Morecambe Offshore Windfarm: Generation Assets Examination Documents

The Applicant's Response Spirit Energy Deadline 1 Submissions

PINS Document Reference: 9.35

TITLE: South Morecambe Platforms
 Unobstructed Airspace

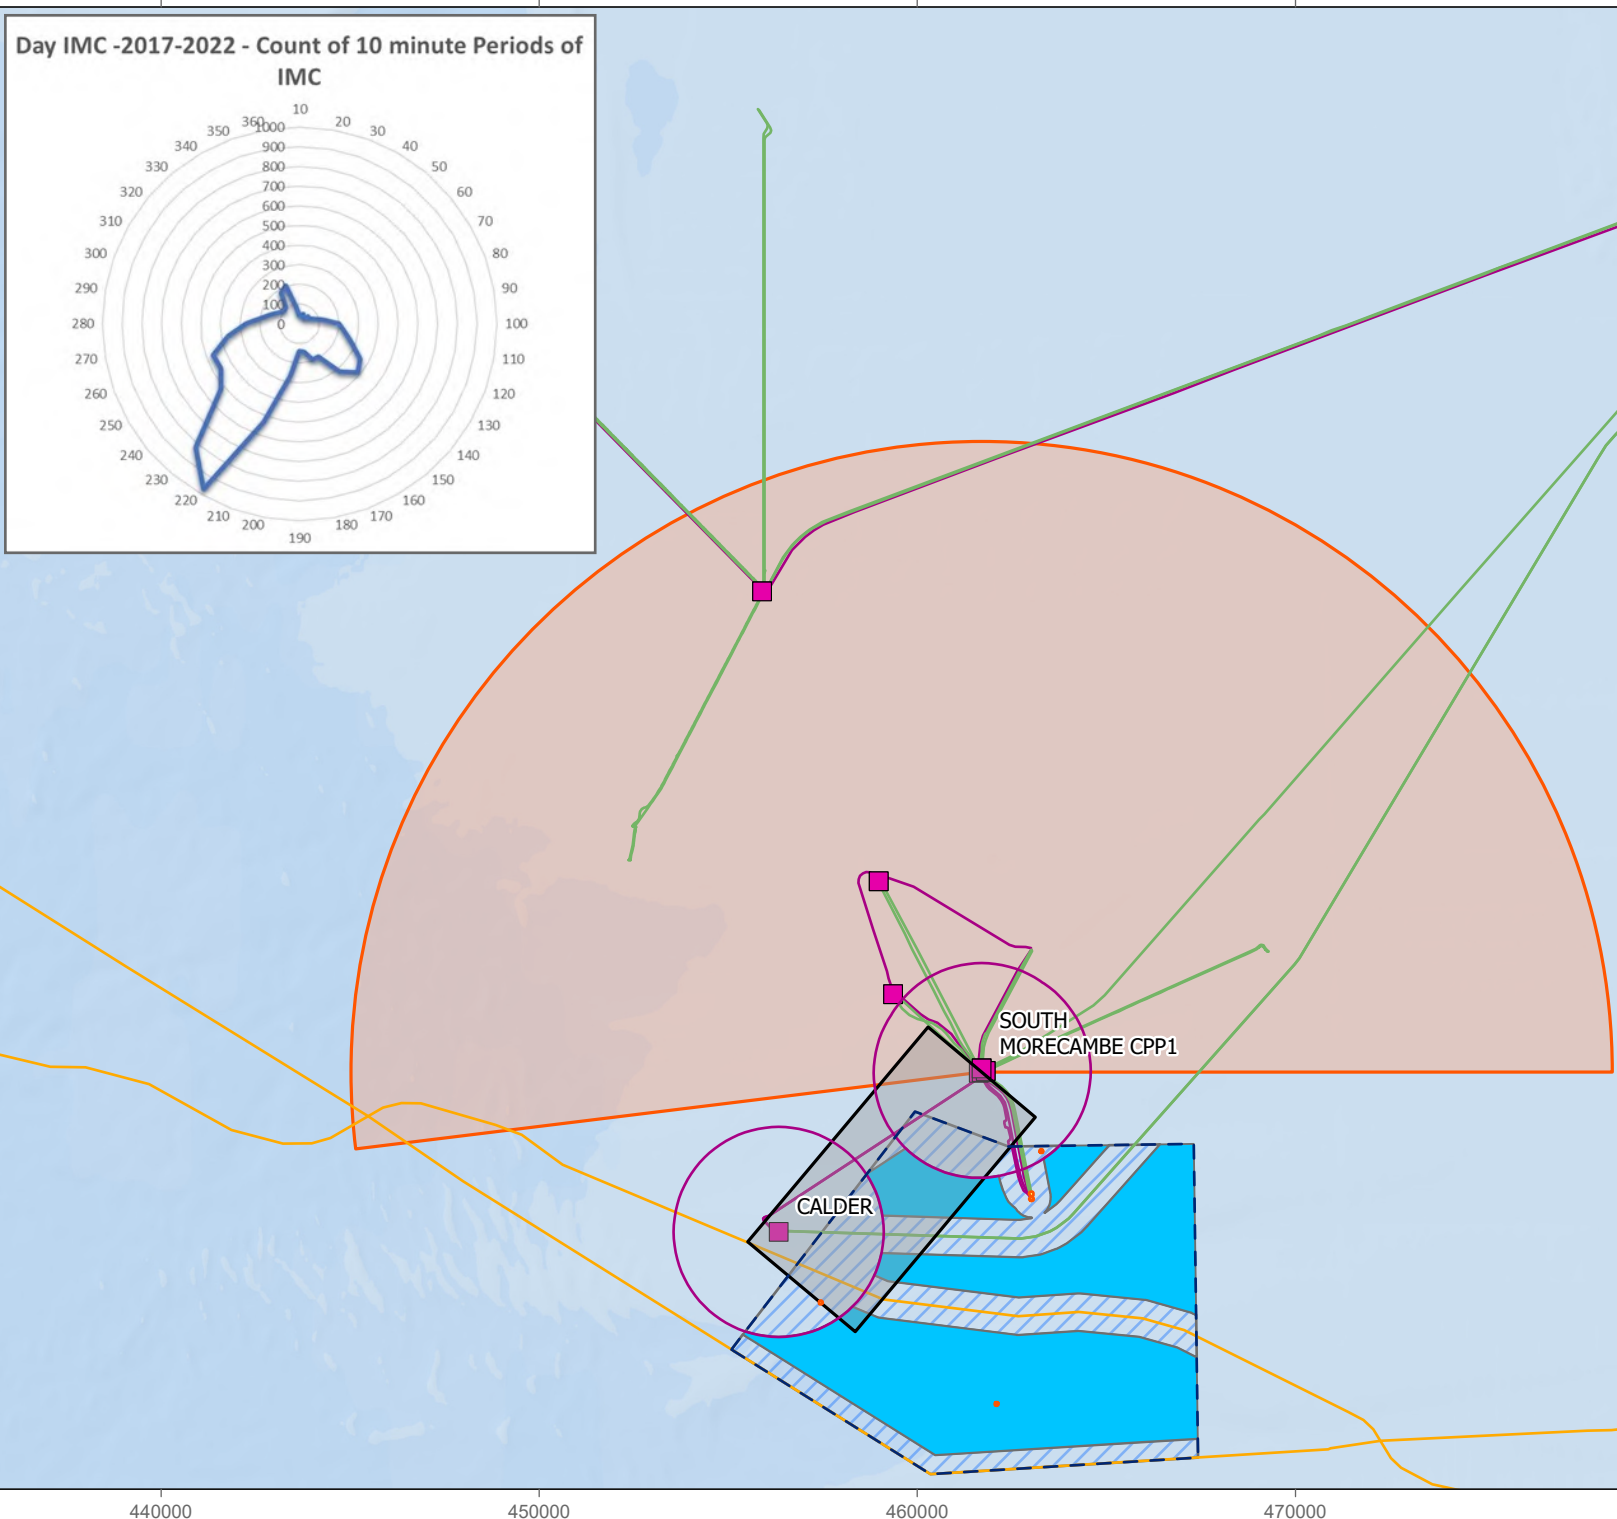
54. Currently, and even following construction and operation of the Project, there is existing unobstructed airspace in an arc from 263^o clockwise to 90^o around the CPC-1 platform as shown on Figure 6.1. This would allow landings from, and take-offs into this unobstructed airspace in both night VMC and IMC to/from the arc from 263^o clockwise to 90^o. As outlined in Section 5 above the Applicant has also proposed additional mitigation, in the form of the Aviation Corridor centred on 220^o in line with the predominant wind direction. This would allow unobstructed landings from and take-offs into this unobstructed airspace to the southwest of the CPC-1 platform.

55. Taken together the effect of the existing unobstructed airspace and the Aviation Corridor would be to provide an approach and take-off distance free of wind turbines for at least 3nm longitudinally, measured from CPC-1 in an arc covering at least two thirds of the airspace around CPC-1. This arc also provides a lateral clearance of at least 1nm from wind turbines. Helicopter
